Commission Directive 2007/15/EC of 14 March 2007 amending, for the purposes of its adaptation to technical progress, Annex I to Council Directive 74/483/EEC relating to the external projections of motor vehicles (Text with EEA relevance)

COMMISSION DIRECTIVE 2007/15/EC

amending, for the purposes of its adaptation to technical progress, Annex I to Council Directive 74/483/EEC relating to the external projections of motor vehicles

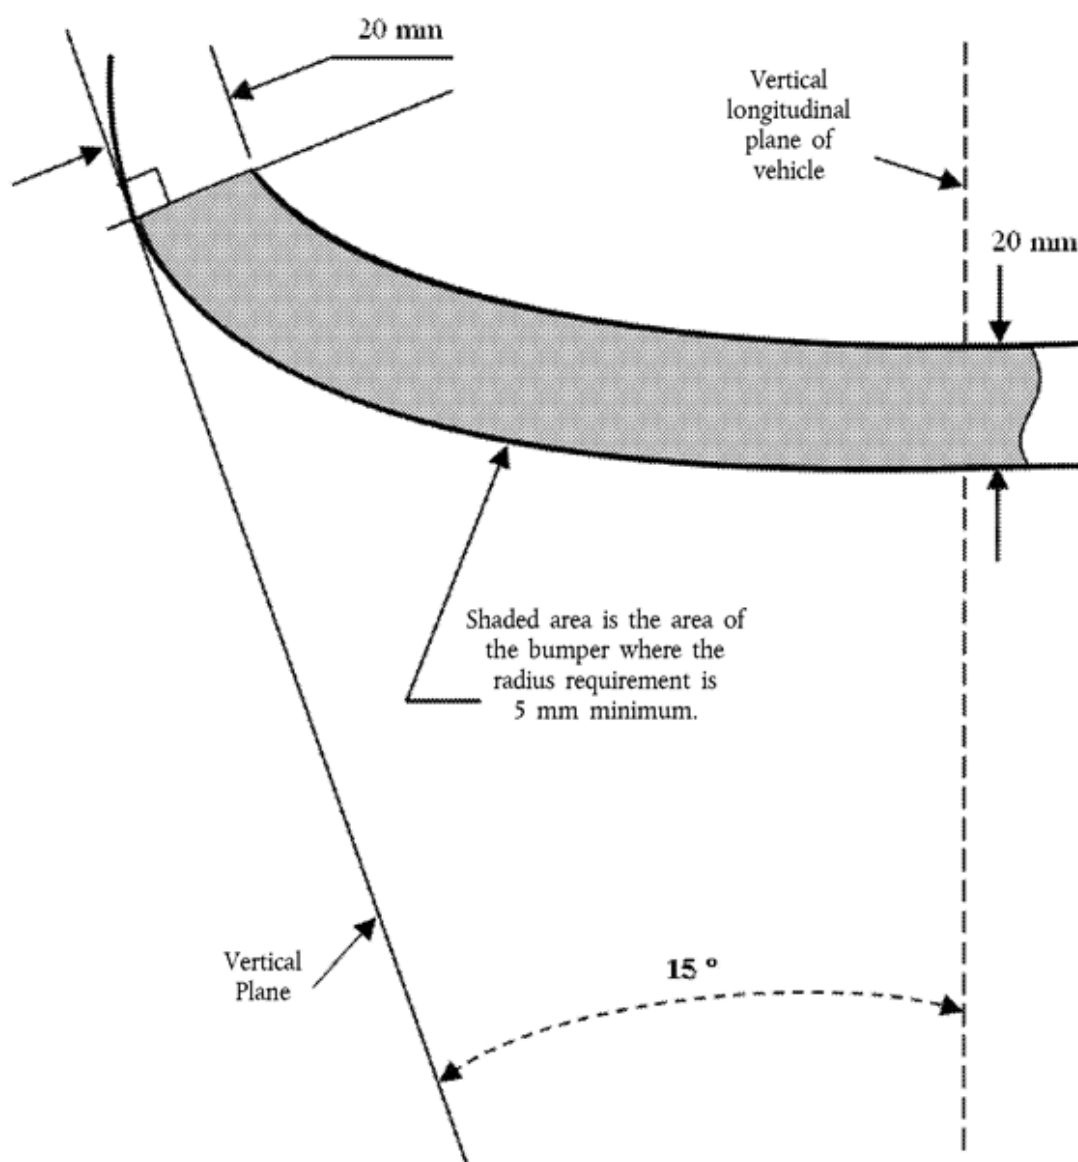
Point 6.5.2. of Annex I to Directive 74/483/EEC is replaced by the following:

6.5.2. If the line of the bumper, front or rear, corresponding to the outline contour of the vehicle, from a vertical projection, is on a rigid surface, that surface shall have a minimum radius of curvature of 5 mm for all points lying between the contour line and lines, above and below the contour line, which are the traces of points 20 mm inside, and measured normal to, the contour line at any point. A minimum surface radius of curvature of 2,5 mm shall apply to all other areas of the bumpers.

This provision applies to that part of the bumper lying between tangential points of contact of the contour line with two vertical planes each set at an angle of 15 degrees with the vertical longitudinal plane of the vehicle (see Figure 1).
